Subject: Callaway Plant, Unit 1 - Amendment No. 12 to License NPF-30

CALLAWAY PLANT, UNIT 1

AMENDMENT TO FACILITY OPERATING LICENSE

Amendment No. 12
License No. NPF-30

FIGURE 3.9-1

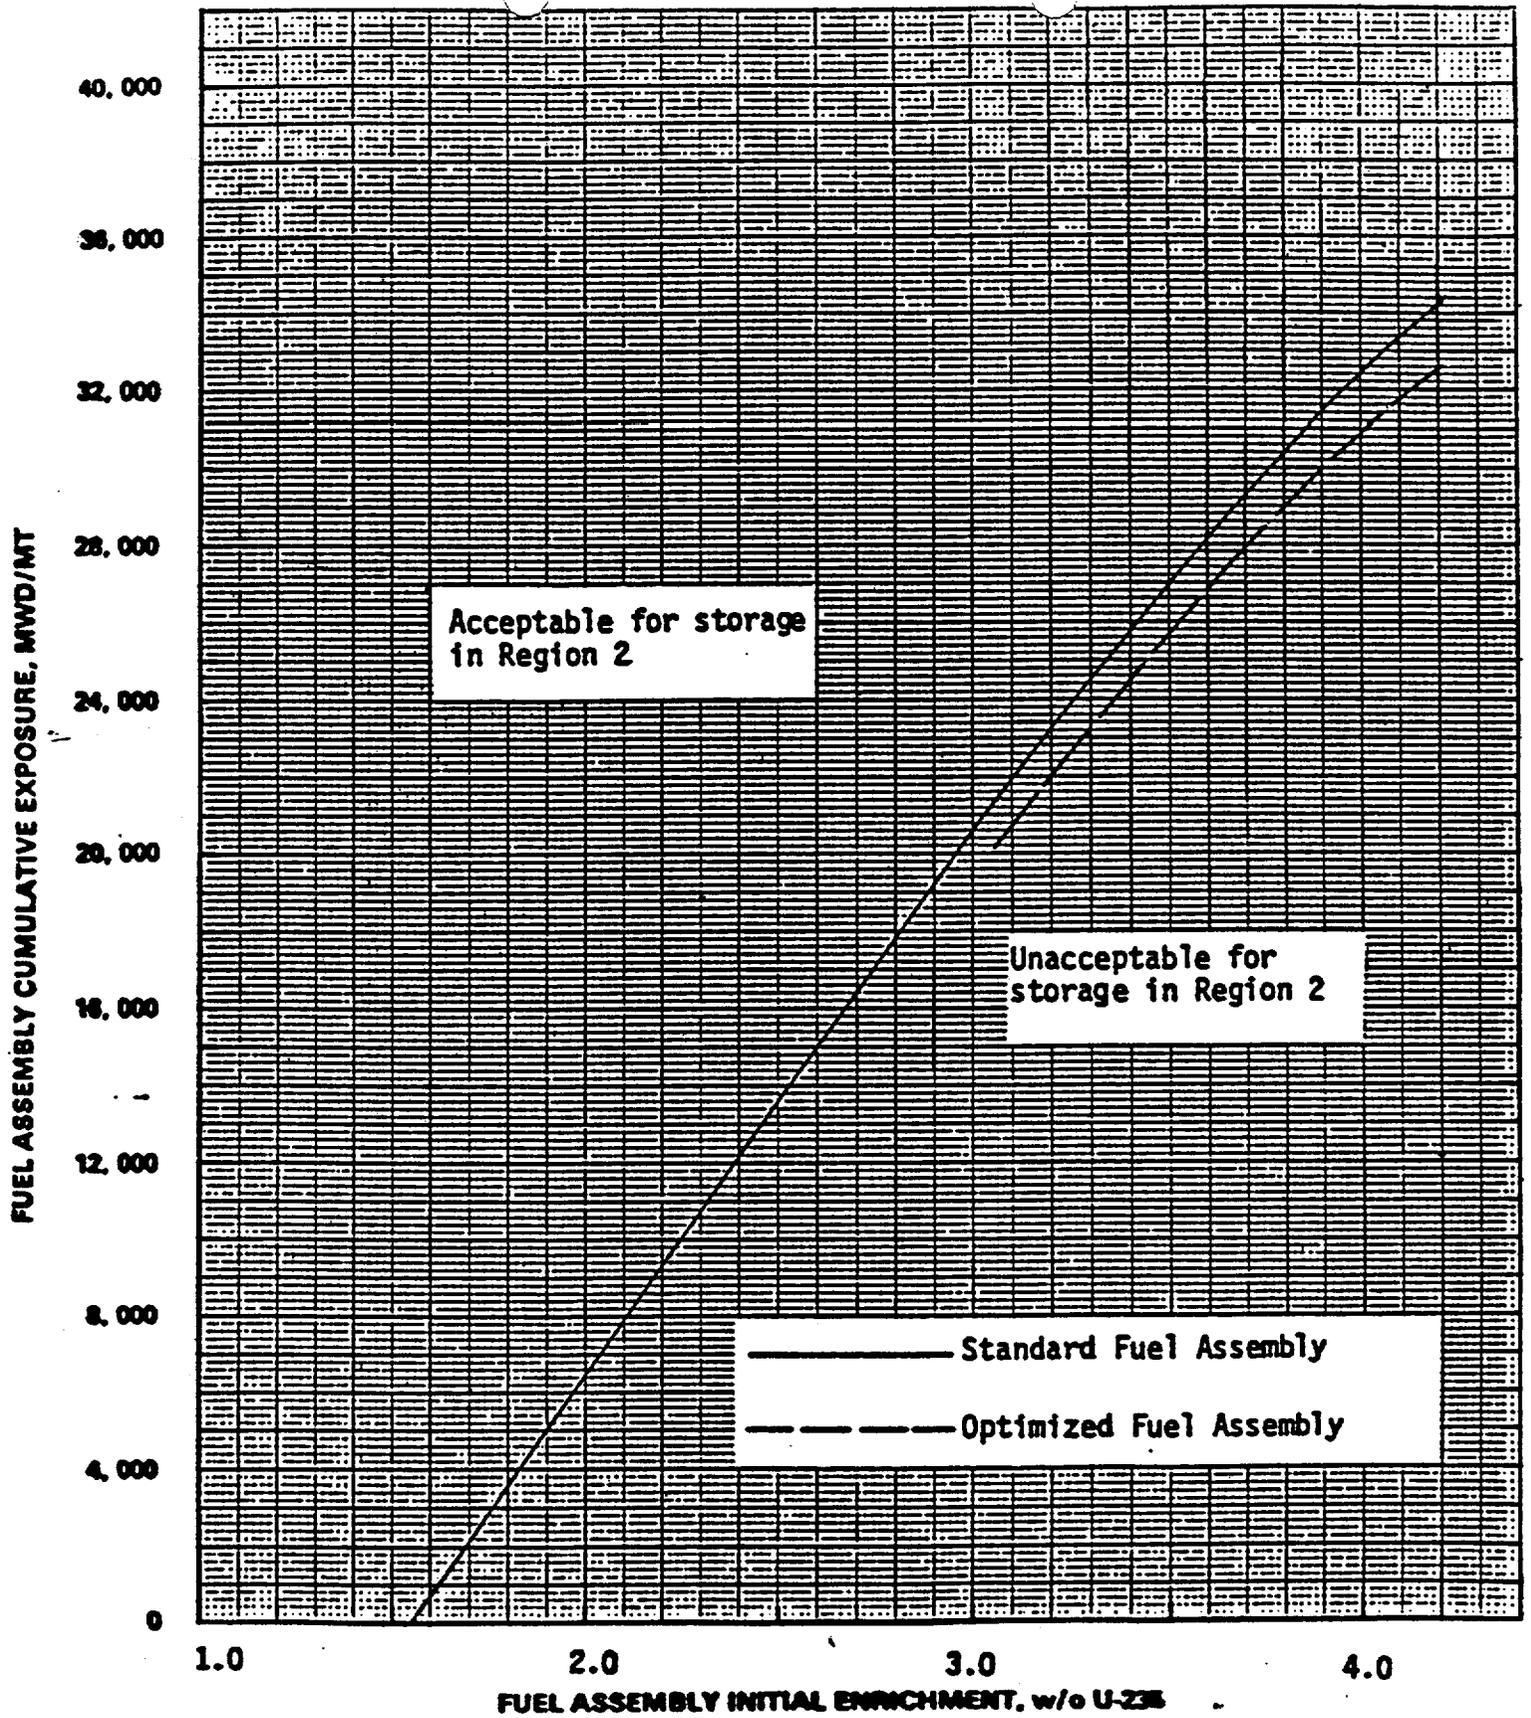
The amendment approves modifications to Pages 3/4 9-16, 5-6 and 5-7, and the amendment approves deletion of Page 5-8 of the Callaway Technical Specifications (TS). The amendment increases the permitted enrichment for storage in the Callaway Plant, Unit 1 spent fuel storage pool from the current value of 3.5 weight percent (w/o) U-235 to 4.2 w/o. This permits extended cycle operation in the Callaway plant and results in larger discharge fuel burnups. Therefore, the curve of acceptable burnup as a function of initial enrichment (Figure 5.6-1 in the present Technical Specifications) is extended. This figure is also amended to include a separate curve for the optimized fuel assembly.

Figure 3.9-1 of Technical Specification 3/4.9.12 is altered to account for the revised analyses and to include a curve for OFA fuel. The revised curves are consistent with the analyses and are acceptable. Specification 5.3.1 is revised to increase the permitted enrichment in the core to 4.2 w/o U-235. This is consistent with the limit for the spent fuel pool and is acceptable.

Specification 5.6.1.1 is altered to delete Figure 5.6-1 (identical to Figure 3.9-1) and to change the figure reference to 3.9-1. In addition the enrichment designation is increased to 4.2 w/o U-235 and the storage location center-to-center spacing is increased to 9.24 inches. These changes are consistent with the spent fuel pool criticality analysis and are acceptable.

A curve of minimum enrichment as a function of critical enrichment was developed using the target value of 0.915. Separate curves were developed for OFA and standard fuel. This is the same procedure employed for the original analysis and is acceptable.
